Report: TAB REPORT
Function: Test, Adjust, & Balance
Date: 08/01/2024

PROJECT
06-17-24 CAVA YUKON, OK (10TH ST)

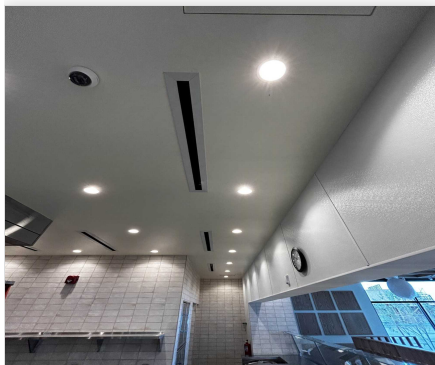
Issue Name : EF2 - AIRFLOW
Description : FAN IS ON HIGH AIRFLOW, NO FAN SPEED CONTROLLER INSTALLED. RECOMMEND INSTALLED SPEED CONTROLLER TO BRING FAN INTO DESIGN.
Created By : National TAB **Assigned To :** National TAB - Will Turnbough
Status : Open
Priority : Urgent **Asset Tag :**
Originated Date : 06/19/2024 - Kristopher Passley - National TAB

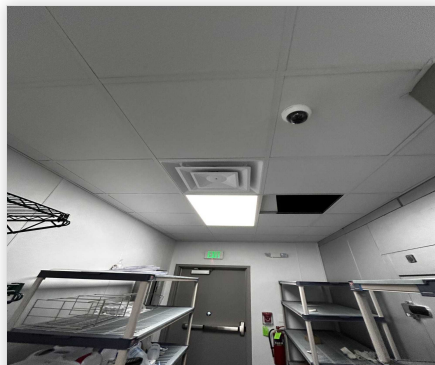
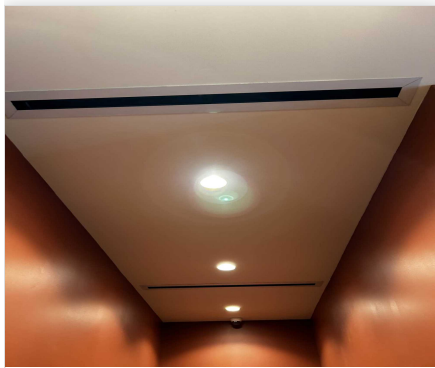
Issue Name : RTU-1 KITCHEN DIFFUSERS
Description : KITCHEN DIFFUSERS 1-1,1-2,1-3 and 1-8 HAVE CLOSED DAMPERS THAT ARE INACCESSIBLE. NEED MECHANICAL TO OPEN OR CHECK FOR BLOCKAGE.
Created By : National TAB
Assigned To : National TAB - Will Turnbough
Status : Open
Priority : Urgent
Asset Tag :
Originated Date : 06/20/2024 - Kristopher Passley - National TAB

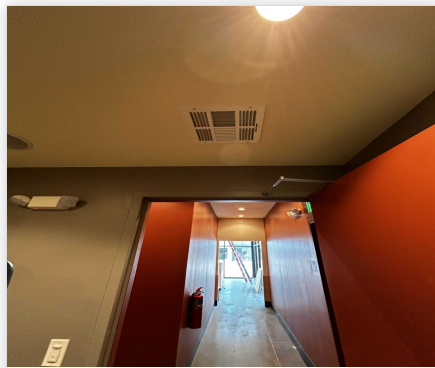
Issue Name : RTU-2 DIFFUSERS
Description : RESTROOM AND HALLWAY DIFFUSERS 2-11, 2-12 and 2-14 HAVE CLOSED DAMPERS THAT ARE INACCESSIBLE. NEED MECHANICAL TO OPEN DAMPER OR CHECK FOR BLOCKAGE.
Created By : National TAB **Assigned To :** National TAB - Will Turnbough
Status : Open
Priority : Urgent **Asset Tag :**
Originated Date : 06/20/2024 - Kristopher Passley - National TAB
